Auxiliaries Sub-Group for Low Temperature Task Force @UN

05mar2020-C.Petitjean (Clepa)

Next steps for Auxiliaries from the agreed drafting document GRPE Geneva

Summary of the written comments received prior end of the day 03mar2020:

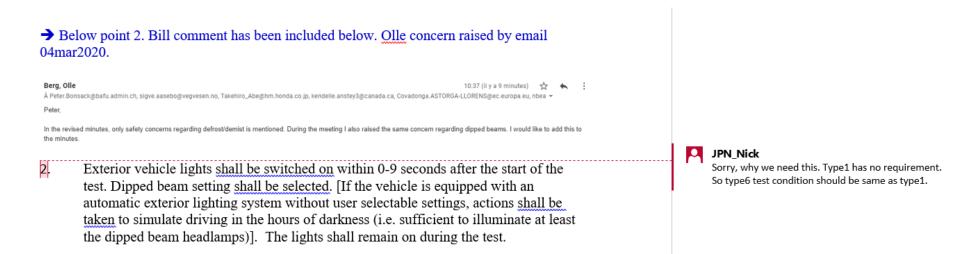
JPN_Nick

It's impossible to set both driver and passenger control within 9 seconds

Christophe proposal = if user manual is checked before then 9 seconds must be enough. Or to we need to extend time of setting ?
